COUNCIL ASSESSMENT REPORT

Panel Reference	2016SCL007
DA Number	DA-13/135/05
LGA	Bayside Council
Proposed Development	<p>Section 96AA Application to modify Development Consent No. 13/135 as follows:</p> <ul style="list-style-type: none"> • Design amendments to the buildings including modifications to the eastern, western and southern elevations to include spandrels and fixed glass louvres, increase in balcony sizes to a number of units to increase articulation of the southern façade of the northern building and the northern façade of southern building, amendments to the location of columns; • Deletion of the planter beds at the end of the corridor which results in the reduction of 209sqm landscaped area; • Amend unit type 2.7, located on Level 5 involving the removal of the entry indent to 16 units and will increase the residential GFA by 32sqm; • Amend Condition Nos. 1, 13(c), 37, 56, 63(b) and 130.
Street Address	659, 661-663 & 669 Gardeners Road, Mascot

List all documents submitted with this report for the Panel's consideration	<ul style="list-style-type: none"> • Amended Plans- prepared by MD+A Architects • Report providing justification for FSR
Report prepared by	Angela Lazar

Figure 3. Proposed location of deleted planter boxes and replace with spandrels

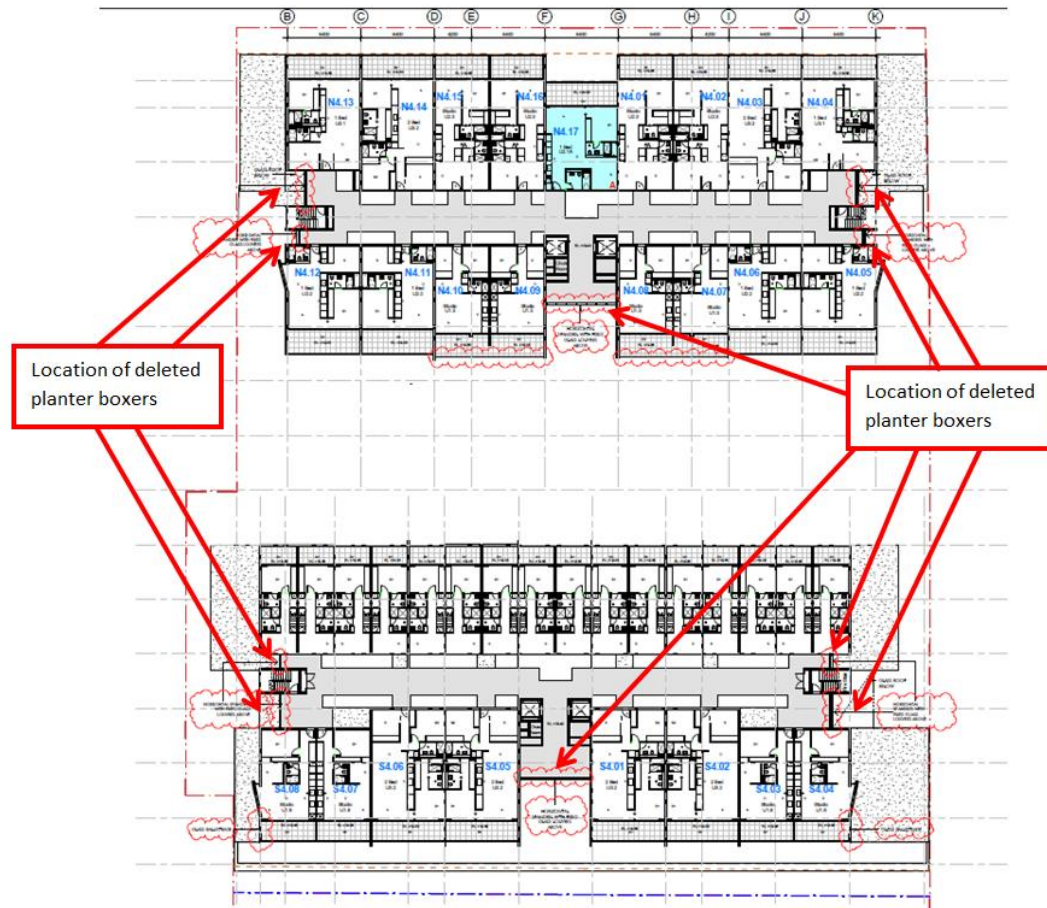
Modification No. 2- Deletion of the planters within the corridors on the eastern, western and southern facades and replace with spandrels

The modification relates to the deletion of the planter boxes located on the eastern, southern and western facades/corridors of Levels 2 to 12 on Building 2 (southern building) and Levels 3 to 11 on Building 1 (northern building). The deletion of the planter boxes will result in a reduction in total landscaped area on the site by 180sqm. In the previous modification approved by the Panel, the total landscaped area approved was 3,098sqm or 35.4%. The proposed modification will result in a total landscaped area of 2,918sqm or 33%. This falls below Council's minimum landscaping requirement of 35% within the BBDCP 2013. Figure 3 below is an example of the location of the planter boxes to be deleted on each level and replaced with spandrels.

As discussed above in Modification No. 1, the planter boxes within the corridors are replaced with spandrels to address wind amelioration as required by the conditions of consent, specifically Condition No. 47.

The loss of landscaped area from the approved 35.4% to 33% of the site area is considered to have minimal impact as these small planters are internal and do not provide the usability of space that the passive common areas of the Level 2 podium and rooftops do.'

As Condition No. 47 was required to be addressed after the approval of the development, the retention of the planter boxes in their current location would be unmanageable to maintain therefore their removal is supported.

Figure 4. Proposed extension and modifications to balconies (on Level 6) to increase articulation

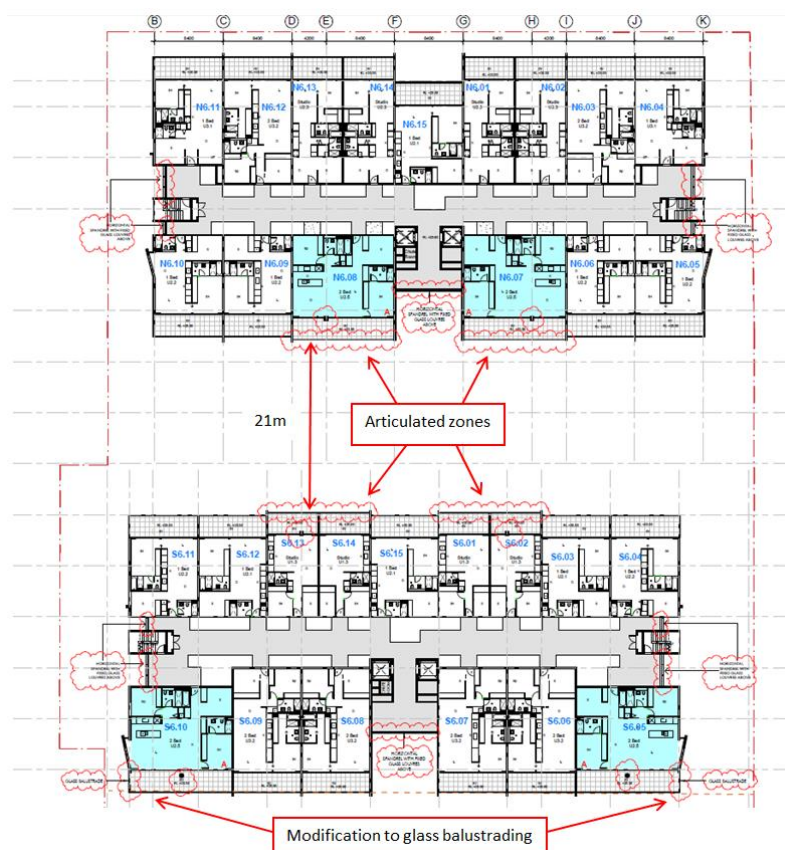
Modification No. 3- Changes to the articulation of the southern façade of the northern building and the northern façade of the southern building

The modification relates to the articulation of the buildings, in particular to a number of balconies along the southern façade of the northern building and northern façade of the southern building. The modifications relate to the central units (on either side of the lift core) between Levels 4 to 8 on the northern building, the central units (on either side of the lift core) between Levels 6 to 11 for the southern building including minor changes to the materials from solid balustrading to glass balustrading along the outer balconies on the southern building between Levels 4 to 12. Figure 4 below demonstrates the changes to the facades on a typical level.

The court approved plans demonstrate a building separation between the northern and southern building of approximately 22 metres to its maximum height. The articulation to these balconies to units on either side of the lift core will reduce the

building separation between the two buildings by 1 metre to 21 metres. The building separation of the remainder of the building is to be retained. The proposal was originally assessed under the RFDC however the building separation controls are identical with the ADG controls, therefore for a building over 9 levels or above in height, the building separation between habitable/balconies is 24 metres. While this is not consistent, the court approved plans departed from this control by 2 metres. The degree in building separation will not create any additional negative overlooking and therefore the modification is supported.

Figure 6. Proposed modification to the entry indents of Level 5 of the southern building

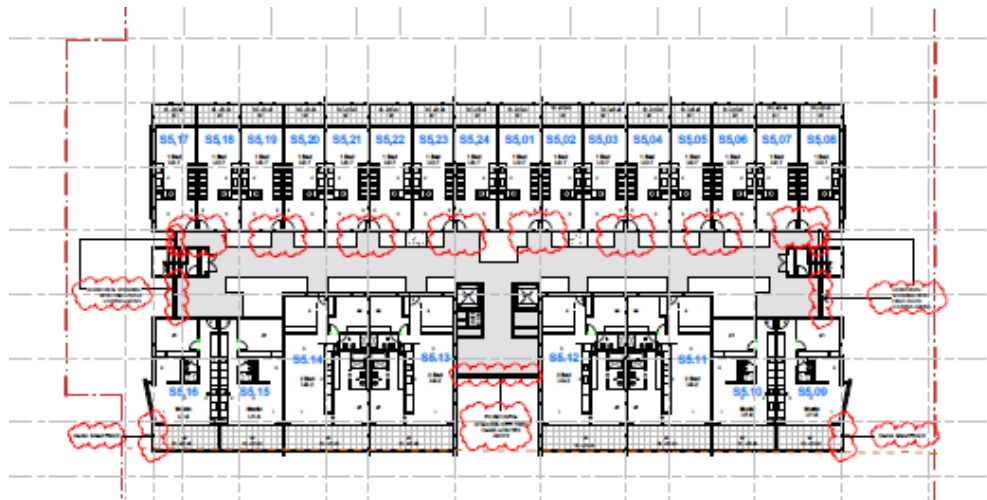
Modification No. 4- Amend the unit type 2.7, located on Level 5 which involves the removal of the entry indent to the unit to improve the unit layout.

The proposed modification relates to amendments to the entry indents within 16 units on Level 5 of the southern building. Figures 5 and 6 below, demonstrate the approved entry indents and the modifications to the units. The applicant has stated that the removal of the entry indents will increase the GFA on this level by 32sqm however the approved GFA will not be altered. The reason for this is that the GFA of the Stage 2 works on the commercial tenancy on the ground floor will be reduced by 32sqm. The commercial tenancy was approved with a GFA of 87sqm which has now been reduced to 55sqm (Figure 7).

As will be discussed further in the report, the corridors were not originally included as part of the GFA of the building. They have now been included as part of Council's FSR calculation and the actual FSR is 3.83:1. As the corridors are included in GFA and the entries to these units extend out to the corridor, there is no additional increase in GFA under this Section 96AA Application, only an increase in the GFA of the residential units. As such, there is no increase in the GFA of the approved development only a shift of the GFA from the retail spaces to the respective apartments. The retail space will remain within its street frontage and will be suitable for a range of retail uses. Therefore, the modification is supported.

Figure 9. Proposed modification to DA.35 showing the return of the upstand parapet

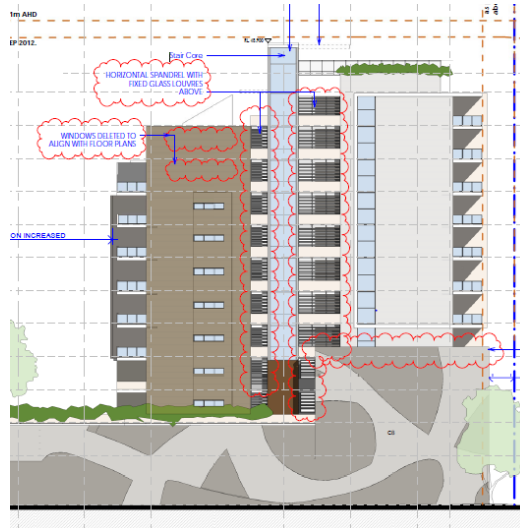
Modification No. 7- Amendments to the design of the proposal showing the solid upstand parapet to the northern elevation and return to the east and west elevation of the podium roof and to reinstate missing windows on the plans

The applicant has stated that during the design development of the proposal, they had noticed an inconsistency between the approved drawings DA.31 Rev G (Northern Elevation Northern Building) and approved Drawing DA.17 Rev H (Level 4) and DA.35 Rev G and DA.36 Rev G (East and West Elevations). Drawing DA.31 Rev G has a solid upstand capping the podium and is the intention of the design. Amended plans have been provided amending DA.17, DA.35 and DA.36 showing the solid upstand parapet and their return on each elevation and plan. These are shown in Figures 9 to 11 below.
